**LHC**

REFERENCE <b>LHC-VC1JX-EC-0001</b>
---------------------------------------

**ENGINEERING CHANGE REQUEST**

**Material Change ATLAS VJ Chambers**

Figure 1: ATLAS Detector Layout

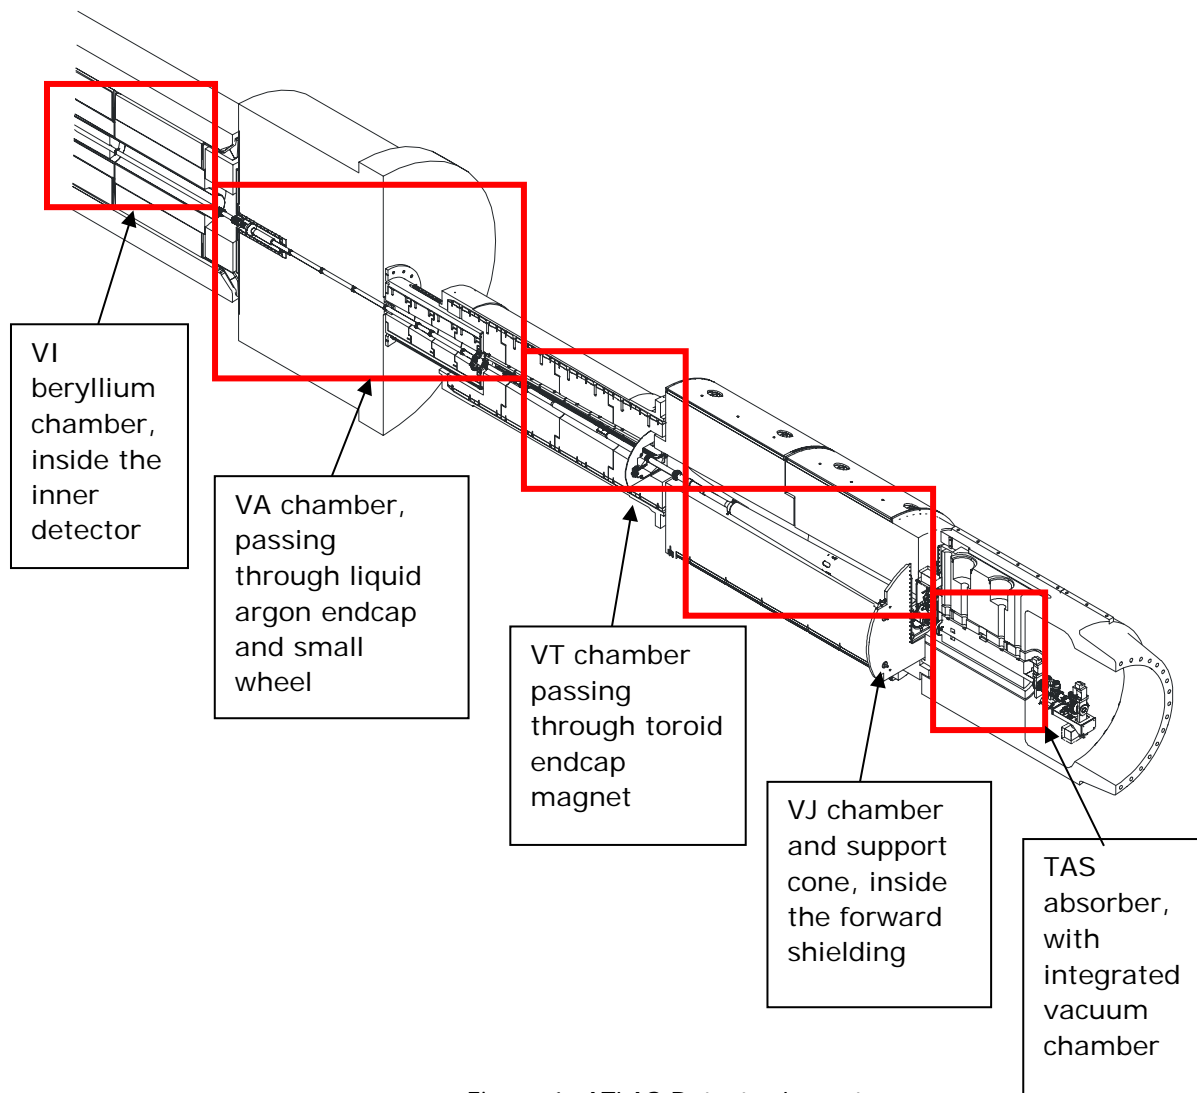
The ATLAS experiment consists of a central vacuum chamber in beryllium at the IP and previously forward chambers in stainless steel. One pair of forward chambers are known as the VJ chambers. These chambers (two in total) are situated symmetrically around the IP in ATLAS. The chambers are situated in the slot between IP1 +/-13207 to +/-18499. They are manufactured in stainless steel to drawing LHCVC1J\_0003. Externally to the chambers is the LUCID detector, which surrounds the chamber in an annular fashion. These chambers interface to the ATLAS VJ extension on one side and to the ATLAS VT chamber on the other side. The chamber is 5292 mm in length, between 80 mm and 120 mm diameter with two stainless steel bellows for flexibility during bake-out to activate the inner NEG coating. Figure 1 shows one half of the ATLAS layout with the location of the VJ and other chambers.
